Re: Expanded Environmental Notification Form, March 15, 2021 and May 11, 2021 Supplement
ADM TMUD Wareham Solar Projects
EEA No. 13940-ADM Tihonet Mixed Use Development
Wareham, Plymouth, Carver, Massachusetts

The Partnership for Policy Integrity (PFPI) submits the following comments on the Expanded Environmental Notification Form (“EENF”) EEA # 13940 to the Massachusetts Environmental Policy (“MEPA”) Unit. PFPI’s work focuses on forests and climate, and our involvement in state policy matters has up to this point largely been confined to biomass energy. However, we are very concerned at how the state’s policy on large-scale solar energy appears to be promoting projects that result in net damage to Massachusetts’ forests, and accordingly are submitting these comments on particular aspects of the Wareham solar projects.

Figure 3. The graph of the relationship between diameter and area (square meters) overlaid on the proponents’ graph of diameter and volume (cubic meters) translated in some unknown way to weight of biomass.

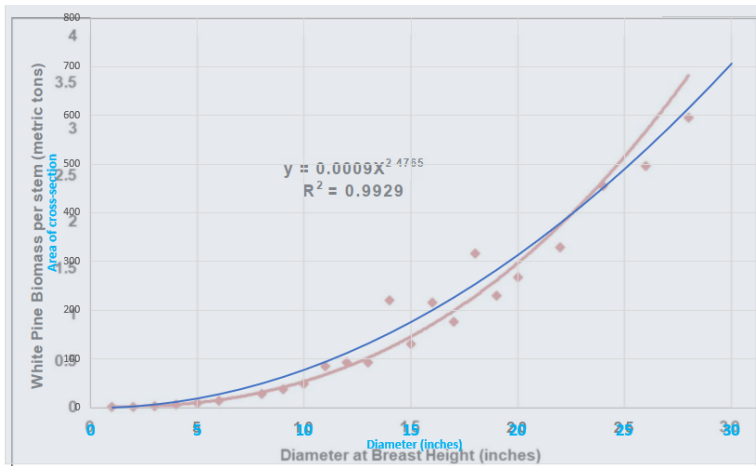
Given this failure and the proponents’ evident unfamiliarity with protocols for ecosystem carbon assessment, we have no confidence in the approach to calculating increased DBH and volume through time, which uses a “simplified, linear growth rate formula.” They do cite a reference for this approach, but it is not clear if their analysis of forest biomass takes into account the fact that trees with bigger circumference tend to also be taller, meaning their overall volume is greater. In fact, the regression curve that proponents provide for volume/weight (cubic meters) looks very similar to a standard curve of the relationship between diameter and area of a cross-section of a tree (square meters), which if the trunk is circular in cross-section would follow the relationship of “pi-r-squared.” We graphed up that simple relationship (in blue) and overlaid it on the on the proponents’ graph (Figure 3):

It appears that the proponents’ analysis of biomass per stem does not correctly reflect the overall increase in volume, because it traces a relationship of DBH to stem cross-sectional area, rather than full tree volume. Further, a stem analysis does not really tell much about forest biomass as a whole, unless there is a detailed count of stems per acre, and the analysis includes the volume of stumps and roots. Even with that information, the analysis of carbon *stocks* is incomplete, because it does not include soil carbon. For an analysis of future sequestration (carbon sinks), however, soil carbon may be difficult to quantify.

For a more credible approach, at a minimum the proponents could use the USFS Forest Inventory and Analysis data and tools that the Forest Service makes available for estimating forest carbon stocks and sinks. Additionally, research suggests carbon sequestration by larger, older trees has in some cases been
